## STAFF REPORT

### PLANNING & ZONING COMMISSION

#### 1. PRELIMINARY DEVELOPMENT PLAN REVIEW

Applicant: The Ohio State University  
Location: 3315 Royal Belfast Boulevard  
Existing Zoning: Liberty Township Planned Commercial and Office District  
Proposed Zoning: City of Powell Planned Commercial District  
Request: To review the Preliminary Development Plan for a medical office building, ambulatory care medical facility, and hospital and to place the property into the City of Powell PC, Planned Commercial District upon annexation.

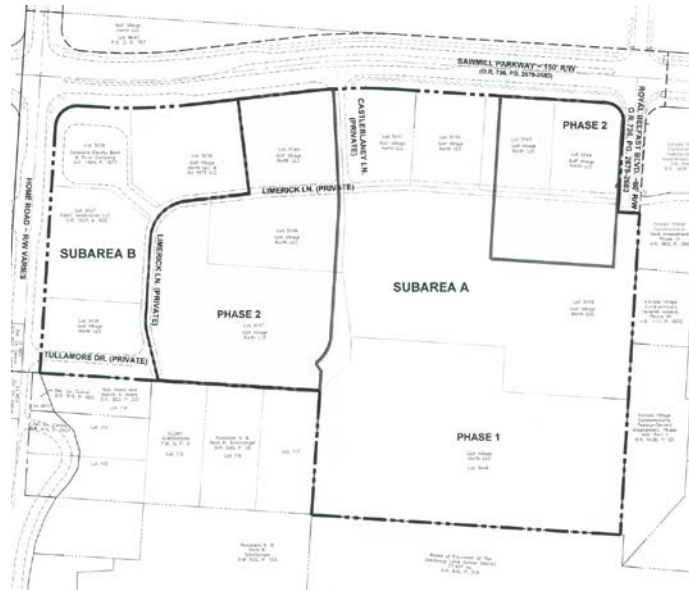
The Architecture for this development is being done on an “inside-out” approach. The applicant has provided some images, but this is going to be an ongoing process. As far as the images that have been submitted go, Staff feels that we need to stay away from the box glass office building and lean more toward the imagery on page 2 of 2, where even though it is of a more contemporary design, adding porch elements and column elements and outdoor patio elements lends toward a more Powell-like design. Also, setting back the upper stories provides for a smaller scale from a human standpoint on the ground. As the architecture progresses, the Commission should provide input. There is no problem for us to continue the architecture discussion to the Final Development Plan stage and beyond, with P&Z giving special attention to reviewing the plans as they relate to our Pedestrian Scale Guidelines.

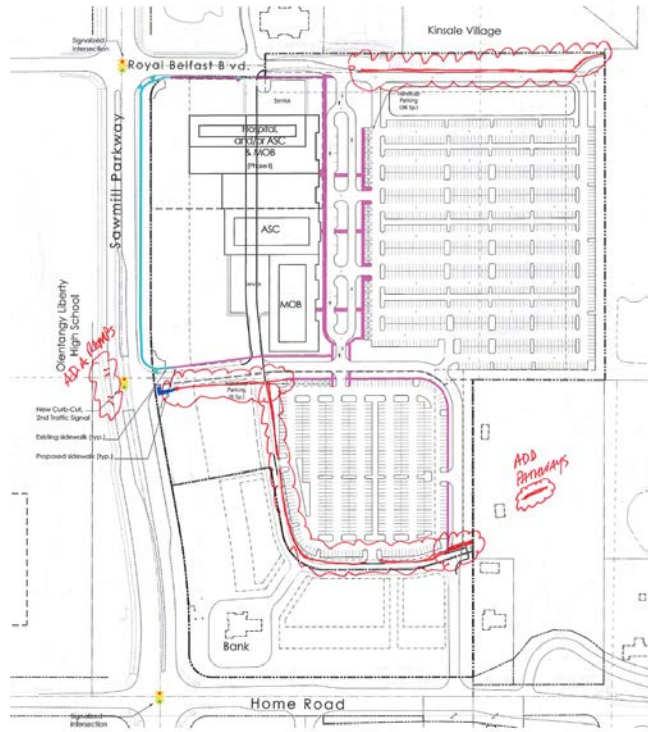
The best thing to say here is that if Powell were going to place a facility like this somewhere within the area, it would be at this location. The location is a perfect location for something that is larger in scale. The high school is actually a very large scale building. The applicant has shown a pathway plan. Staff believes that this could be enhanced as follows:

3. That the pathways be added as recommended by Staff.
4. That the applicant consider adding revisions to the plan as recommended by the Architectural Advisor.
